**Requirements by Transit New Zealand for  
Designation of State Highway 2  
(Tauranga Eastern Arterial)**  
**and**  
**Tauranga District Council  
for Bell Road Interchange**

| <b>Addendum to Requirements by Transit New Zealand for Designation of State Highway 2<br/>(Tauranga Eastern Arterial) and Tauranga District Council for Bell Road Interchange</b> |           |
| <b>Section A – Assessment of Effects of Proposed New Alignment from Bell Road<br/>Interchange to Kaituna Road.....</b>  | <b>1</b>  |
| <b>Section B – Design Adjustment at Paengaroa Interchange.....</b>  | <b>12</b> |

FIGURE 3.10

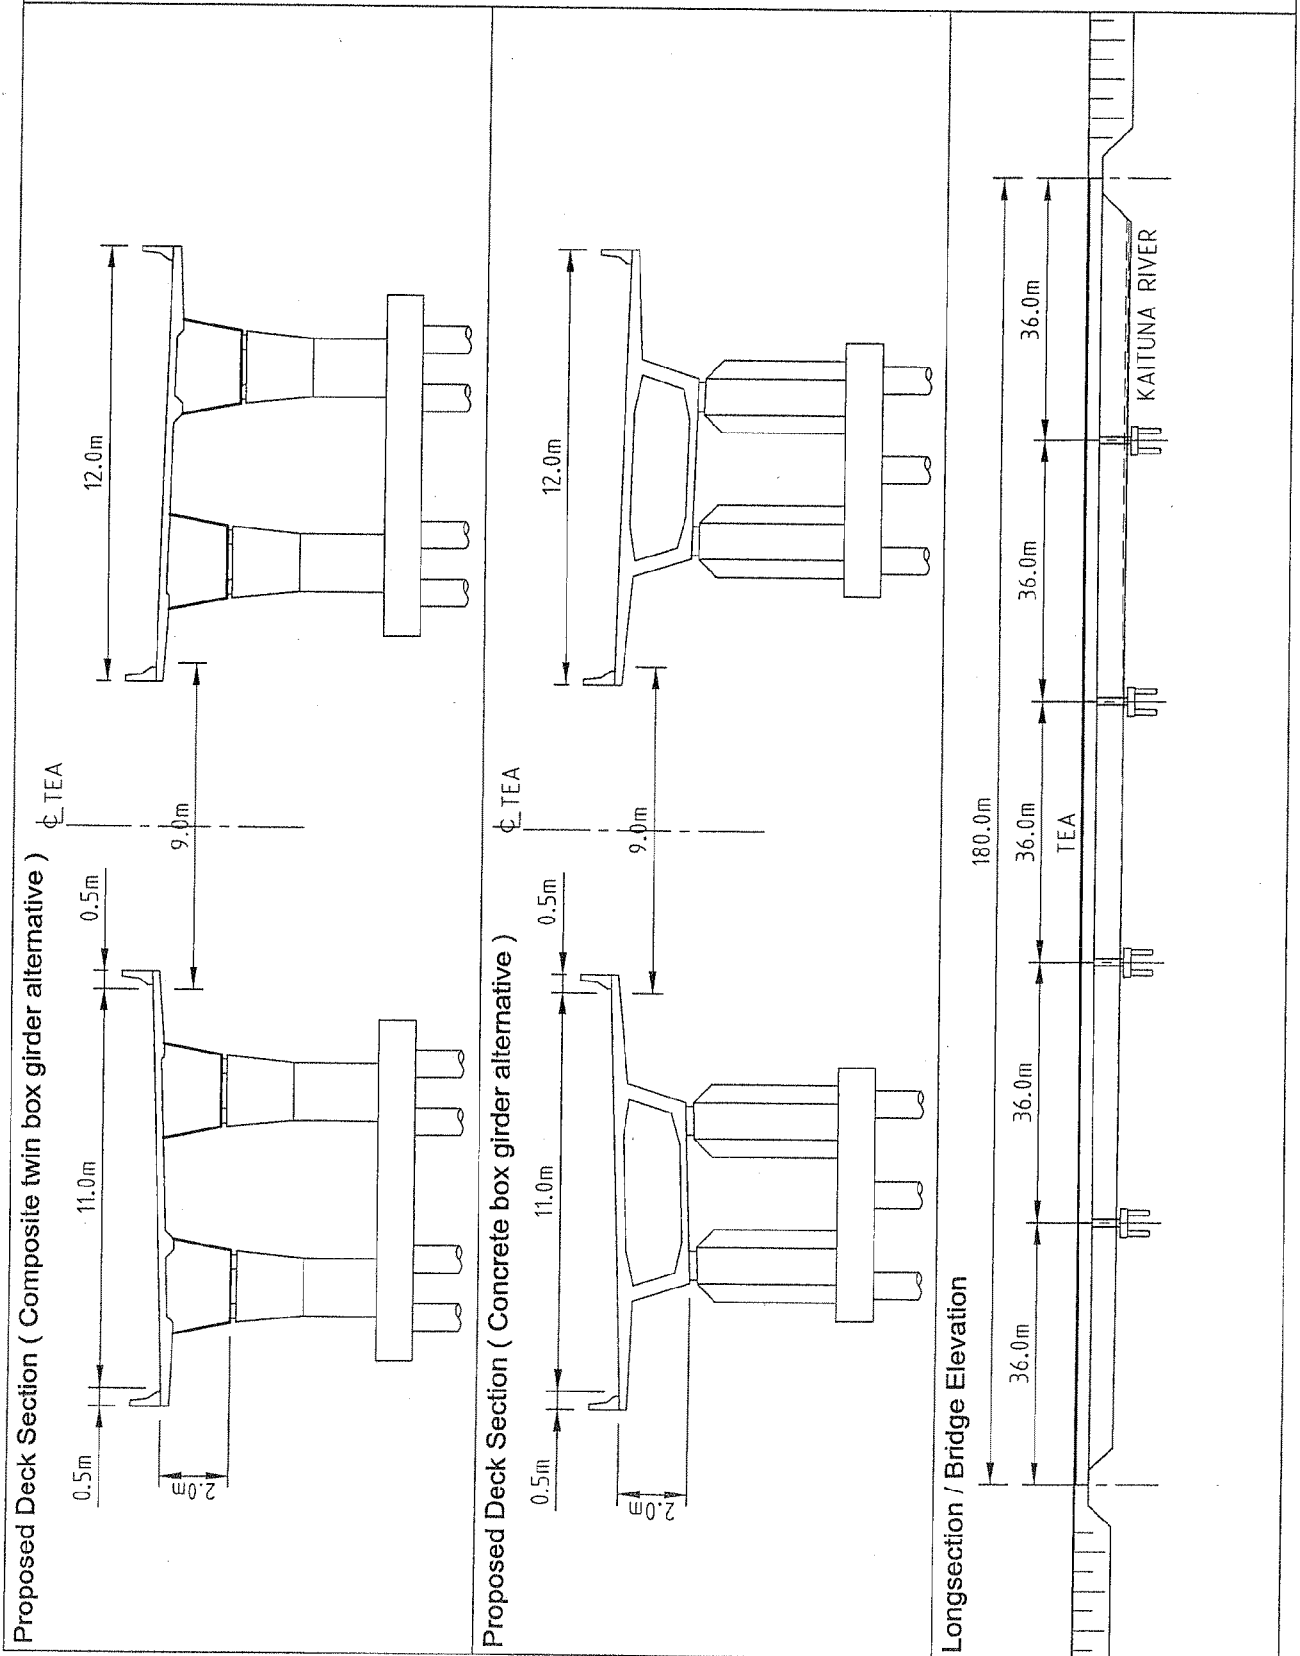
The new bridge structure (D) will replace bridge 6 and consist of twin 2 lane bridge structures carrying the northbound and southbound traffic respectively over the Kaituna River. Each bridge is 180m long and comprises a 5-span layout with 36.0 m spans, and is 23.0 m wide between parapets (see Figure 3.10).

Each carriageway deck consists of a composite section comprising twin, single cell, steel box girders with cast in situ concrete deck slab to provide a 2000 mm deep section. The abutments comprise perched bearing beams supported on extended piles through the embankment, and the piers comprise single columns under each box-girder spine supported on a piled foundation, founded at 10 m depth.

Alternatively, for a deck constructed by the incremental launch technique, the deck depth would have to increase significantly for a 5-span layout with a 40 m interior span. A continuous, prestressed concrete, single cell box-girder deck, 2.7 m deep is proposed.

Figure 1

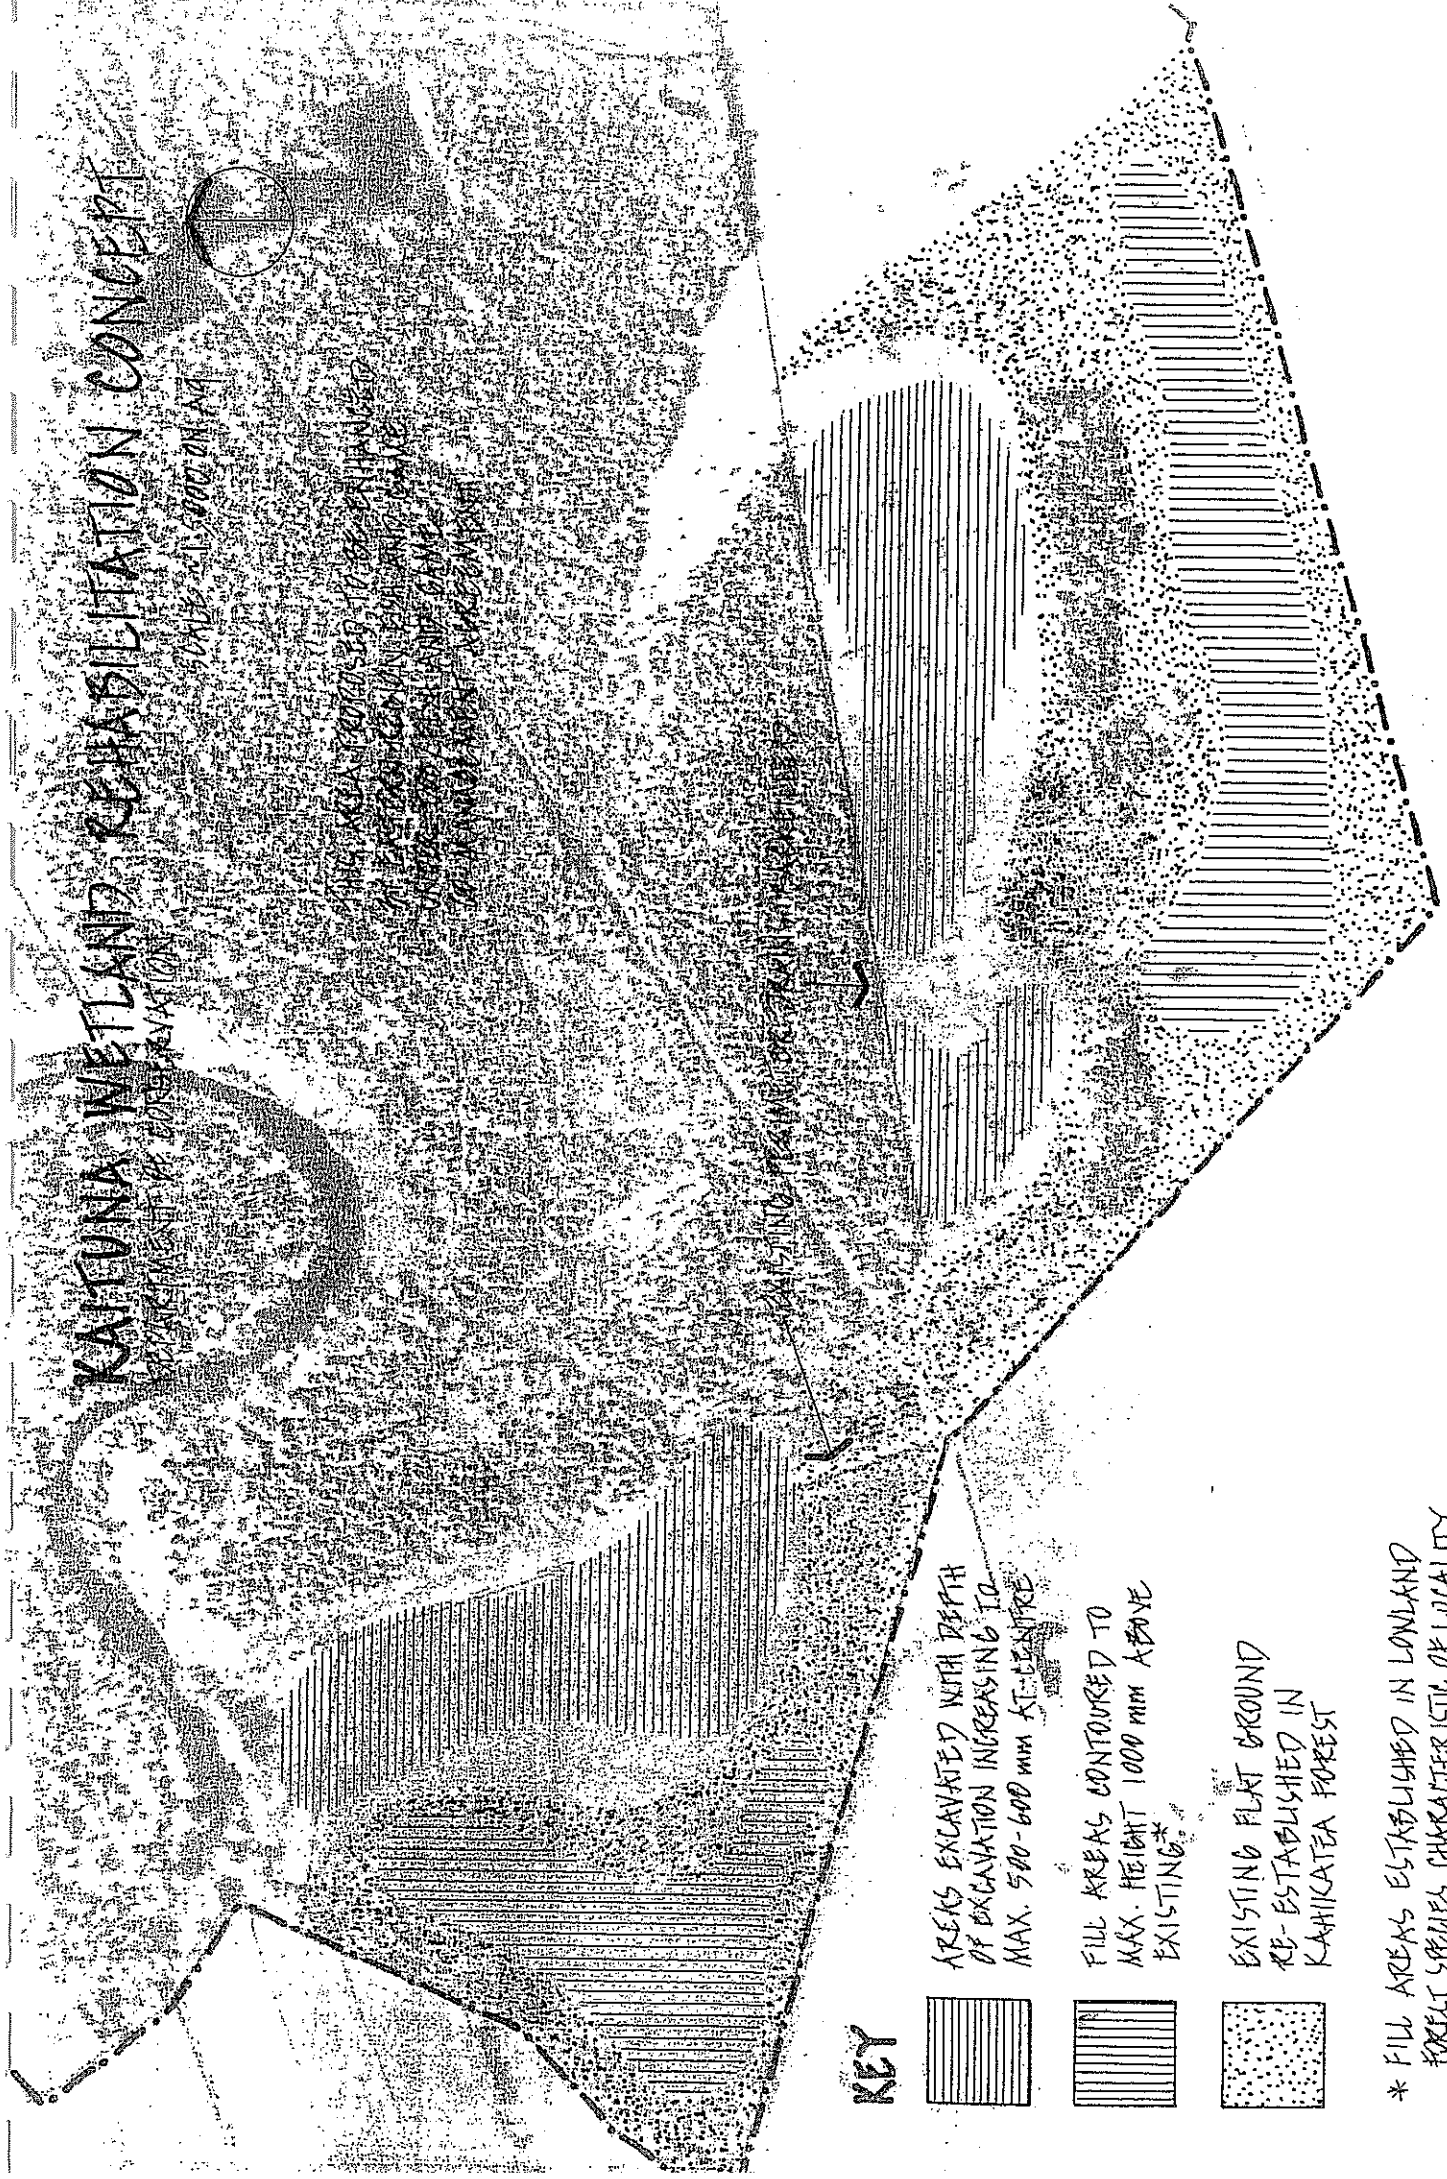
grazing area and the opportunity for wetland replanting. The Department of Conservation has advised that the 40 ha of pasture in the south western portion of the reserve, currently grazed, is to be rehabilitated by the Department to wetland and kahikatea forest subject to the outcomes of the Management Plan process and resolving a rating issue with Environment BOP for the Kaituna Catchment Control Scheme. The Management Plan for the Reserve will be prepared over the next three years. The rehabilitation objective is to create a diversity of wetland ecosystem and kahikatea forest, with some areas of mixed lowland forest to enhance habitat values for primarily terrestrial species while providing the reserve a degree of buffering from activities that could occur on adjoining land.

The Department anticipates that excavated areas and their margins, together with an area of low-lying wet ground at the eastern end (about 17 ha in total), will largely be left to succeed naturally into wetland vegetation. Selective weed control to facilitate natural succession will be the main active management in these areas. Kahikatea forest (14 ha) and mixed-species lowland forest (7 ha) will be established through an active planting programme, with an intensive maintenance programme (mainly weed control) operating through the first three years after planting. Refer Figure 1.
